Reply to referee F. Comiti (#3)

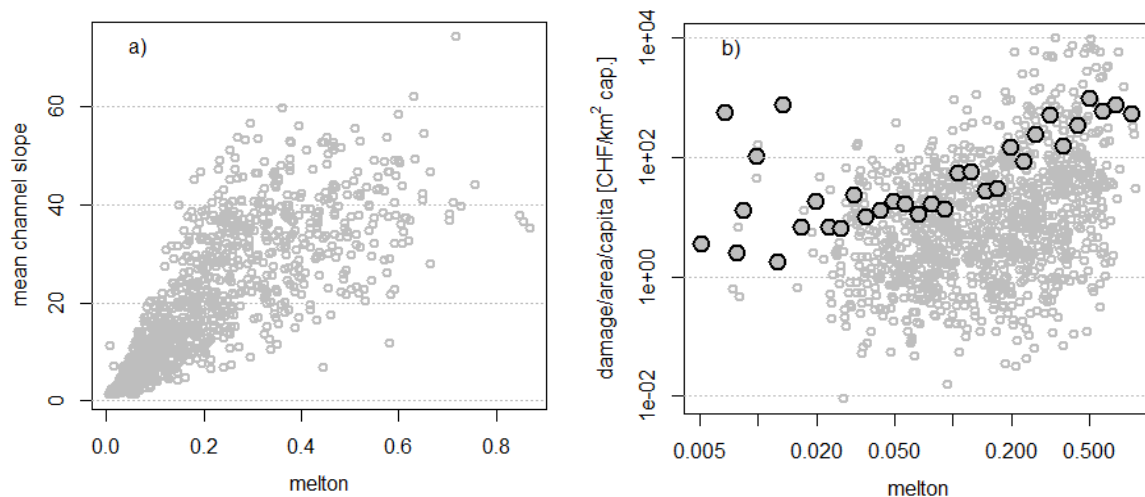
→ *The information about the whole catchment steepness is better conveyed by the Melton number.*

The Melton ratio is determined by dividing the height range of a hydrological catchment (difference of the max. elevation and the min. elevation) by the square root of the area of the catchment: [Melton ratio = $(Z_{\max} - Z_{\min}) / \text{area}^{0.5}$]. Unfortunately, for our database it is generally impossible to derive the exact hydrological catchment associated with a given bedload damage point. We explicitly addressed this issue above (and also in our reply to comment [d] of referee no. 1).

However, we calculated the Melton number for each municipality. We thereby used the highest and lowest elevation and the area of the municipality. We are not sure if such an analysis even makes sense for areas that are not hydrological catchments. The relation between mean channel slope and the Melton ratio is shown below in figure (a). Most of the affected municipalities show a low Melton ratio and a low mean channel slope. The relation between municipal bedload damage costs normalized by area and population and the Melton ratio is given in the figure (b) below. The grey circles represent the individual municipalities affected by bedload transport damage between 1972 and 2011. The black circles represent binned means. We can see that higher damages per area and capita can be detected with higher ruggedness of the terrain.

We did not include these results in the manuscript since the Melton ratio is normally not calculated for politically defined areas such as a municipality (in contrast to topographically defined catchments).

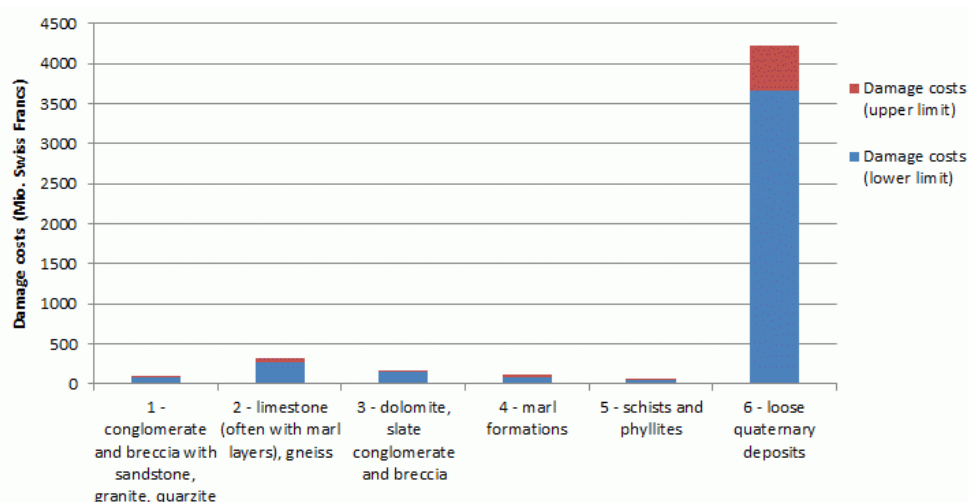
→ The geological setting of the different subareas is not considered at all, and I think it should.

To give some basic information about the geological/geotechnical characteristics within the seven subareas, we added a column to table 1 in which the predominant lithology in the subareas is summarized. This description is based on the Geotechnical Map of Switzerland (BFS GEOSTAT/BUWAL).

In an additional step, we summarized the solid rock units of the Geotechnical Map of Switzerland into five lithological-geotechnical classes according to their susceptibility to mechanical weathering (according to their morphologic resistance, bedrock will yield different amounts of material to bedload transport in steep streams). While class 1 shows a very small susceptibility to weathering, class 5 is weathered rather easily. A sixth class contains the few different Geotechnical Map units of loose quaternary deposits that can be very easily mobilized. We then distributed the bedload damage costs (according to the spatial information in every single database entry) to the six lithological-geotechnical classes as shown below in the graph. The distribution of damage in classes 1 to 5 shows no obvious correlation with the vulnerability to mechanical weathering. Actually, most of the bedload damage costs fall into the loose quaternary deposits class (>83%). This can partly be explained by the fact that bedload damage occurs in settlements, along streets and rivers that are generally situated on alluvial deposits. Even in steep terrain in mountainous areas damage is going to result in the valley bottoms where goods and infrastructure are concentrated. We added a few sentences to the text to refer to this fact. However, because the underlying information provided in the database does not allow to define hydrological catchments, we are regrettably not able to investigate the upstream interaction between geological/geotechnical setting and the generation and transport of bedload. We thus refrained from including further investigations on the role of geology to our manuscript.
